**VEHICLE FACTORS GROUP CHAIRMAN'S
FACTUAL REPORT**

Vehicle Attachment – MCI Vehicle Reports

HWY17MH005

Service Bulletin No. 118

Figure 1: DL3 Routing and Connection Details

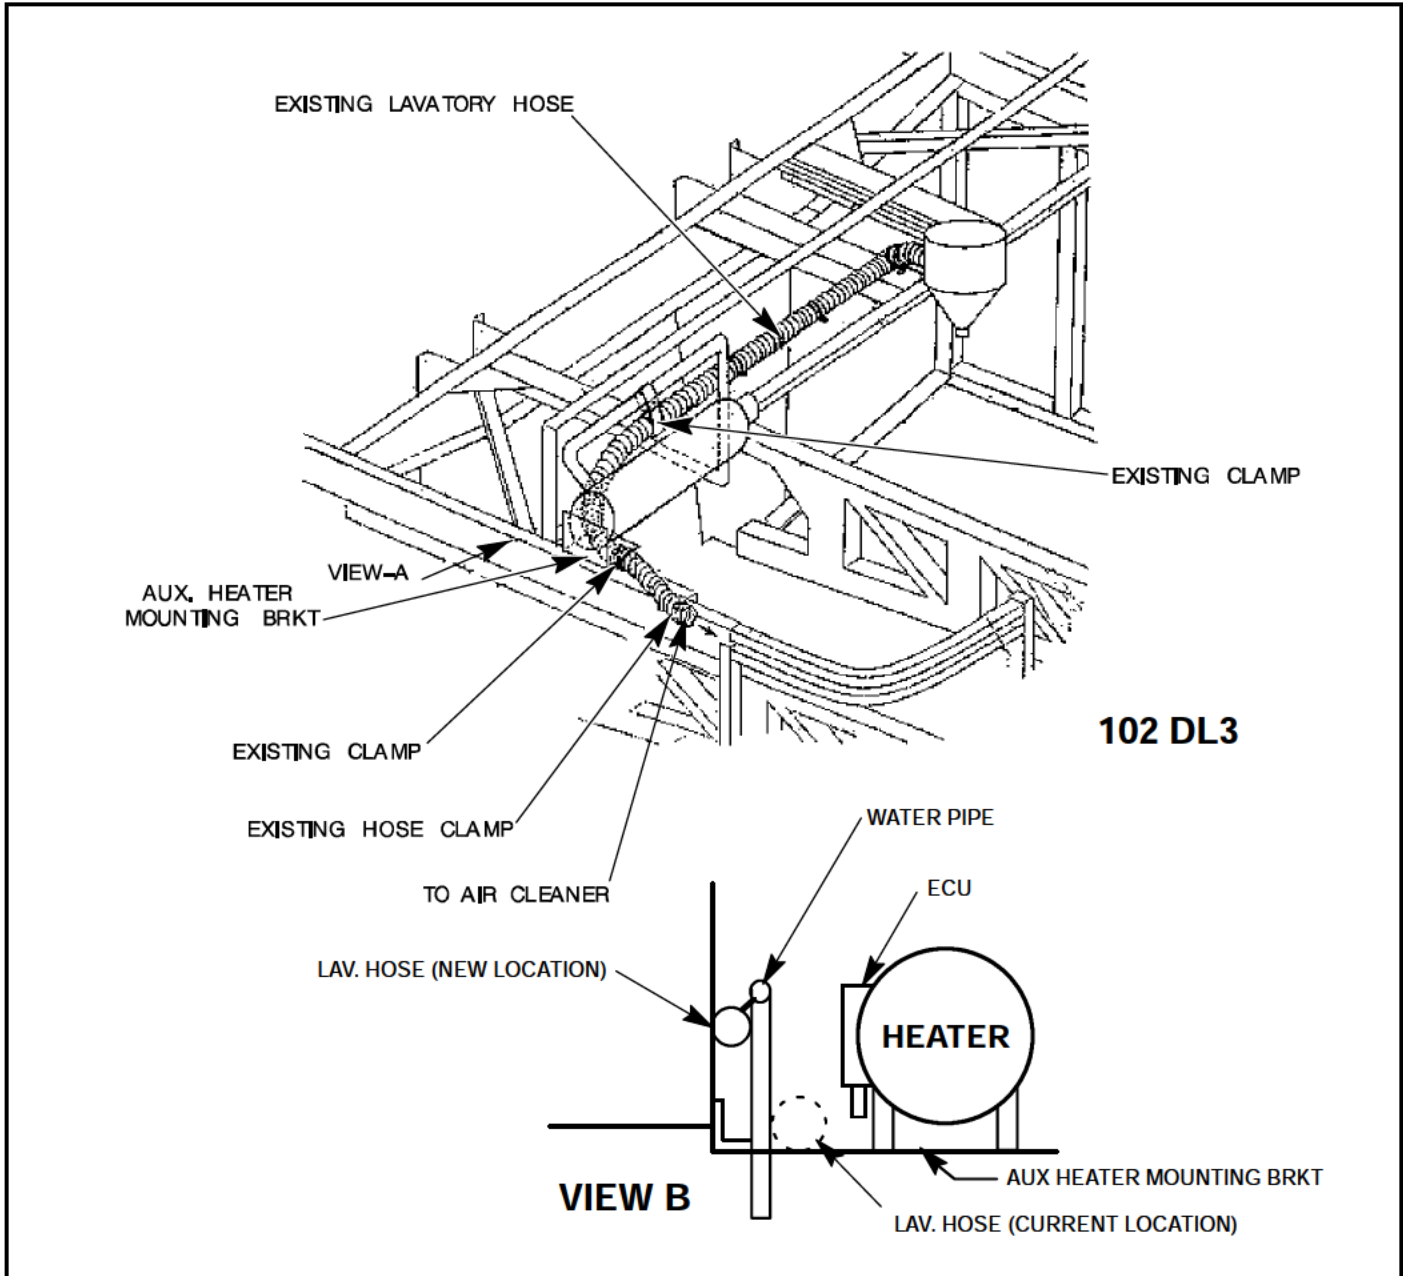
1. Loosen the hose clamp and remove the lavatory hose from the air cleaner (Figure 1).
2. Remove the two securing clamps from the auxiliary heater mounting brackets (Figure 1).
3. Inspect the lavatory hose and auxiliary heater harness for damage. Replace these if necessary. The part numbers are 7L-12-1219 for the harness and 17L-4-2 for the hose.

4. Route the lavatory hose between the water line and the wall of the rear cross seat, clamping it to the water supply line with the 19-4-144 clamp and the existing clamp, using the hardware supplied (Figure 3).

5. Reclamp the hose to the end of the heater mounting bracket and clamp the hose to the air cleaner (Figure 2).
6. Do a final inspection to check the lavatory hose for clearance from the ECU and auxiliary heater wiring harness.

Figure 4: D3 Routing and Connection Details

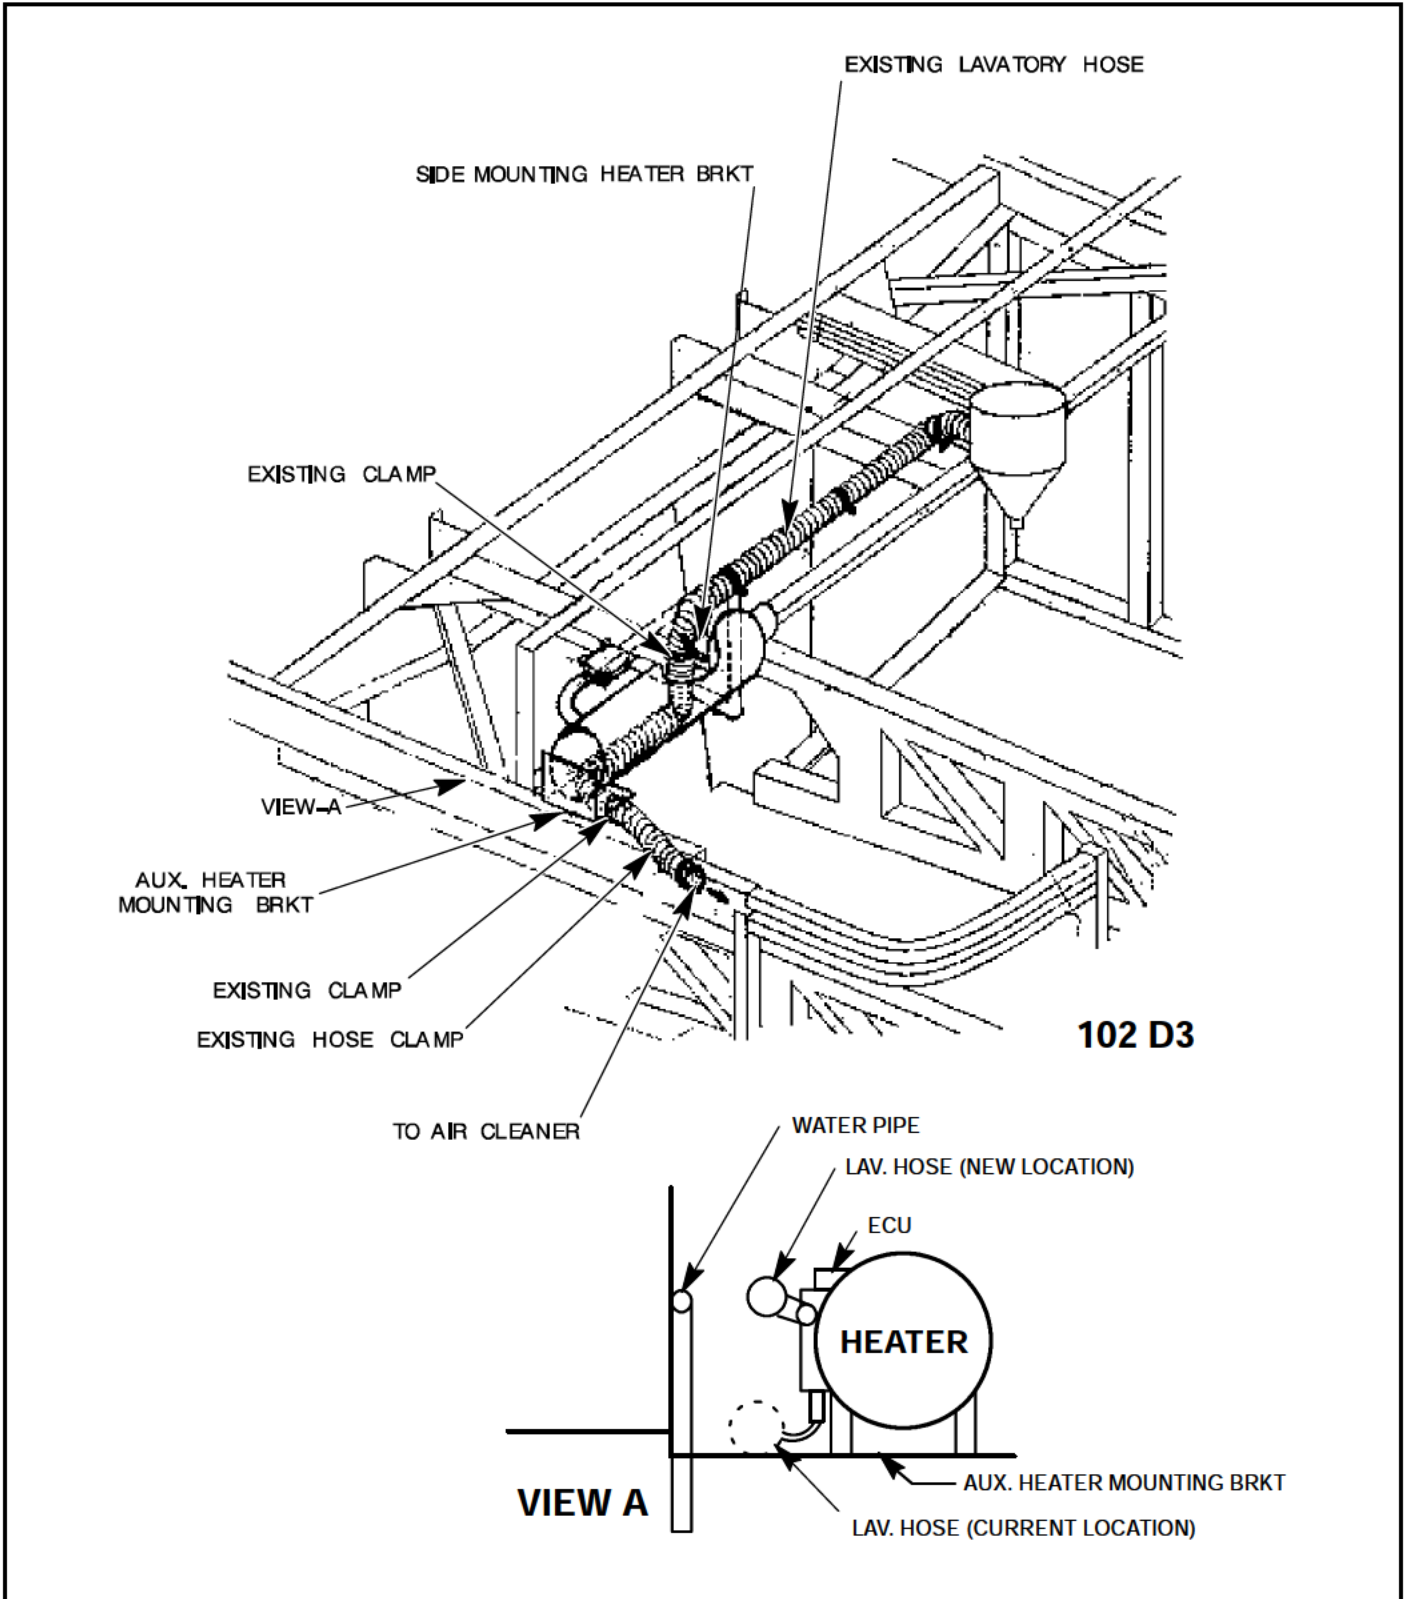
1. Loosen the hose clamp and remove the lavatory hose from the air cleaner (Figure 4).
2. Remove the two securing clamps from the auxiliary heater mounting brackets (Figure 4).
3. Inspect the lavatory hose and auxiliary heater harness for damage. Replace these if necessary. The part numbers are 7L-12-1219 for the harness and 17L-4-2 for the hose.
4. Route the lavatory hose over the water supply line and beside the auxiliary heater, clamping it to the the side heater bracket using the existing hose clamp and the hardware provided. Figure 5 shows the present routing, and Figure 6 shows the correct routing. Figure 7 shows the clamping location.

Figure 1 Alternator Ground

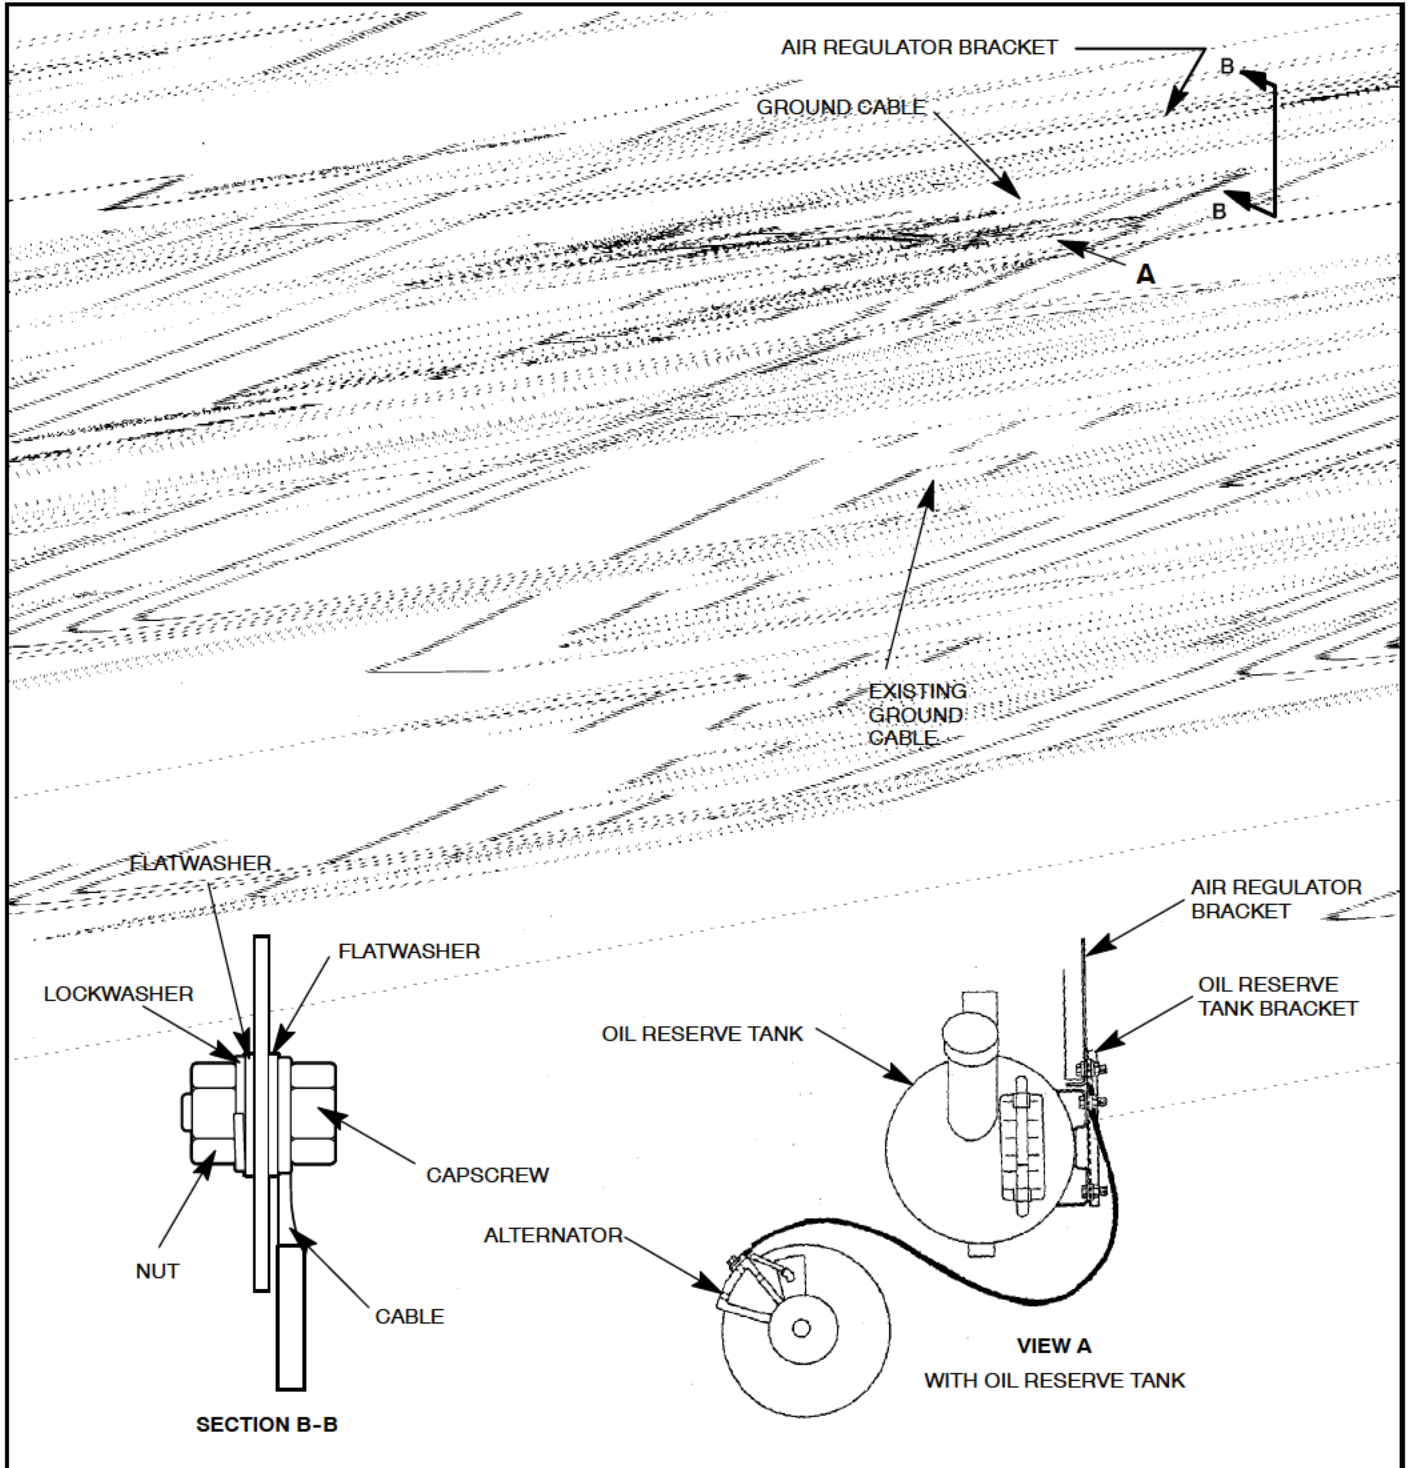
Effective with units [REDACTED], a secondary ground cable is added from the alternator to the frame. This ground is recommended by the alternator manufacturer and is added by using the following procedure.

1. Prepare the alternator ground surface (the machined surface on the front housing) by scraping off any paint and/or sanding the machined surface to bare metal.
2. Connect the additional ground cable to the alternator with the capscrew, lockwasher and flat washer provided (Figure 1). Torque to 25-35 lb-ft.

4. For engines with an oil reserve tank:
 - a. Route the cable over the alternator and under the reserve tank to the air regulator bracket per view A of Figure 1.

- d. Use the capscrew, lockwasher and flatwasher provided to secure the cable (Figure 1, Section B-B). Due to the confined nature of this area, it may be necessary to install the capscrew from the front side of the bracket, and to place the nut on the back side.

5. Inspect the existing ground cable connection to the frame stud and engine block (Figure 1). If the connection is loose or corroded, remove the connection, sand all contact surfaces to a clean shiny appearance, and reassemble the connection.

Figure 1. Brake System With E-10 Brake Valve and Parking Brake Interlock.

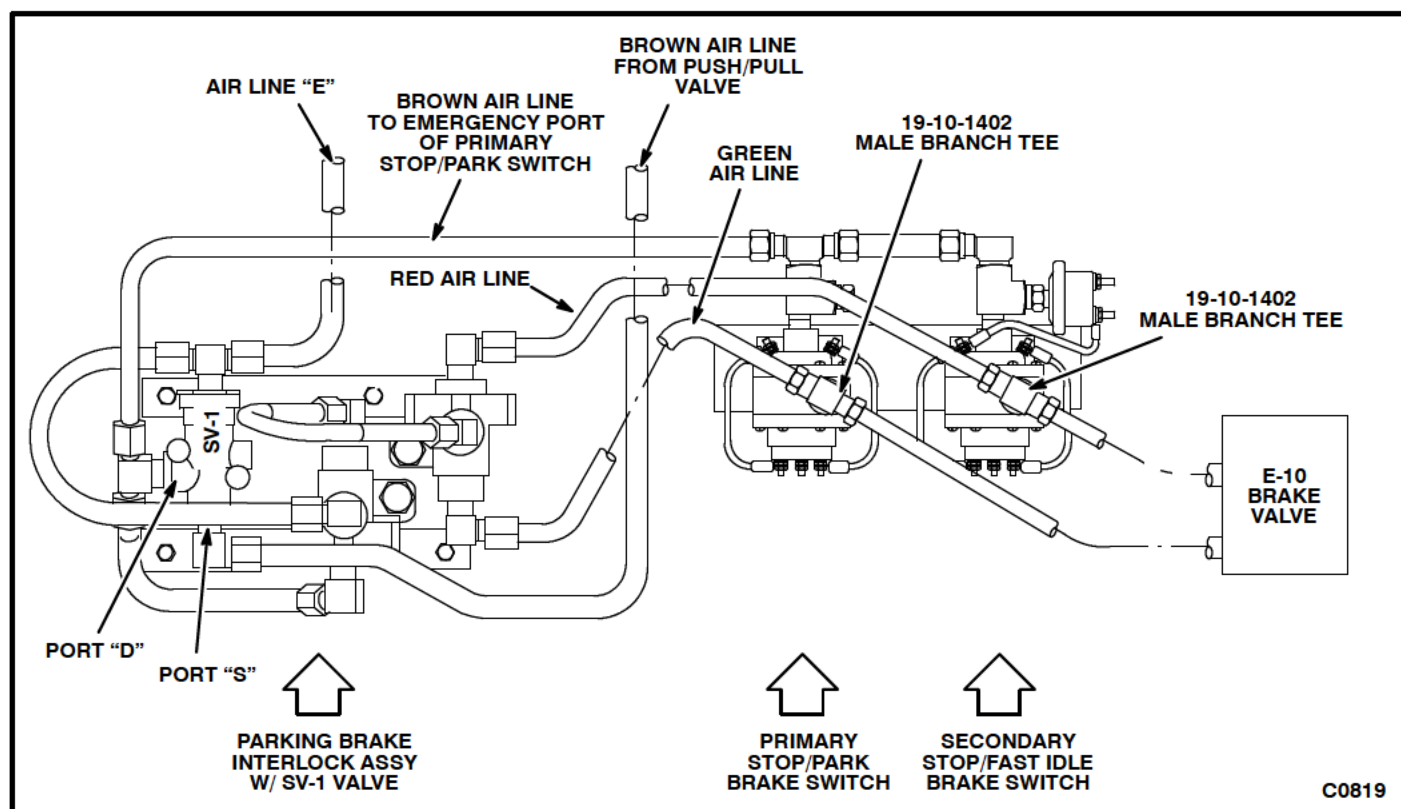
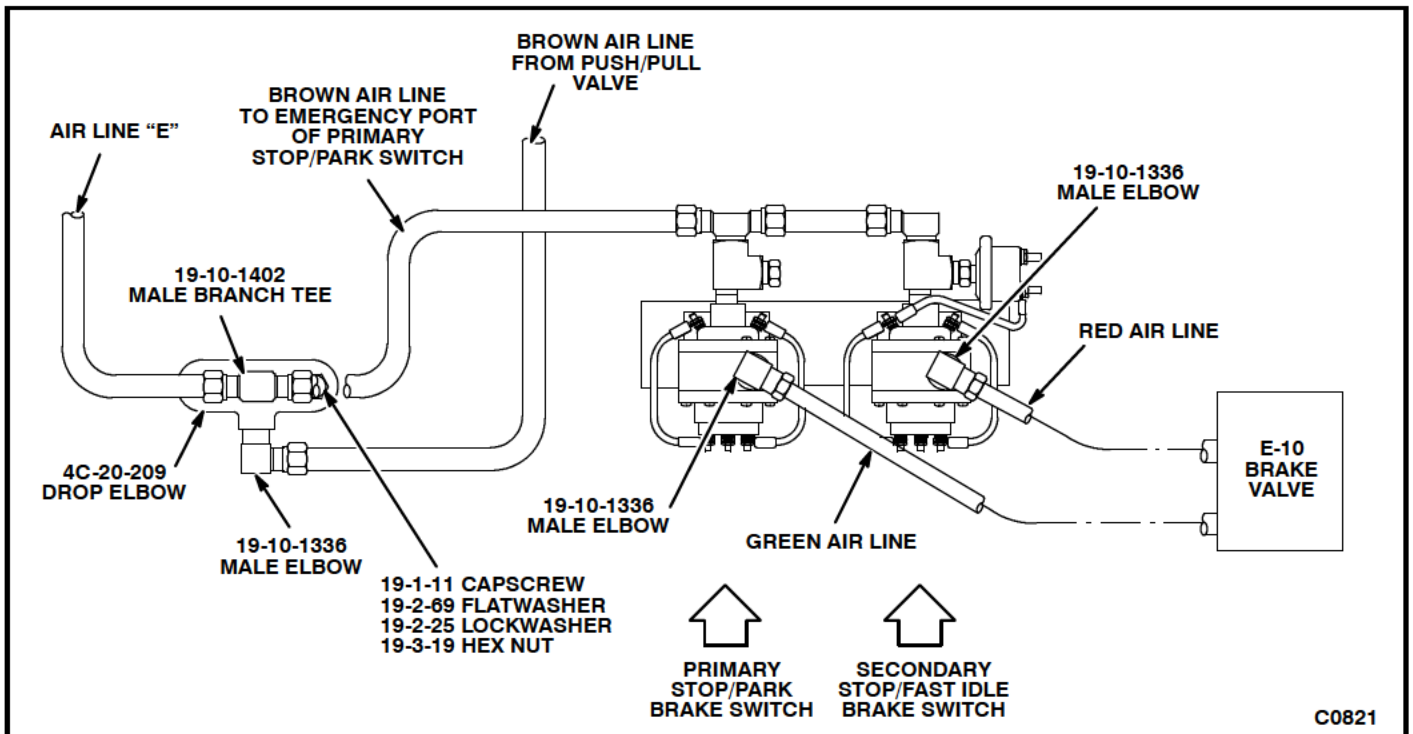
Effective with unit 48127*, MCI redesigned the braking system on 102D3 and 102DL3 coaches by removing the interlock between the parking brake and service brakes.

2. Open the front bumper and remove the spare tire from the tire compartment.
3. a) On coaches having an E-10 brake valve, disconnect the air lines to the 19-10-1402 male branch tees on the primary stop/park switch assembly and the secondary stop/fast idle switch assembly (see Figure 1). Replace the tees with 19-10-1336 male elbows (see Figure 3). Reconnect the red and green airlines running between the switches and the E-10 brake valve (see Figure 3).
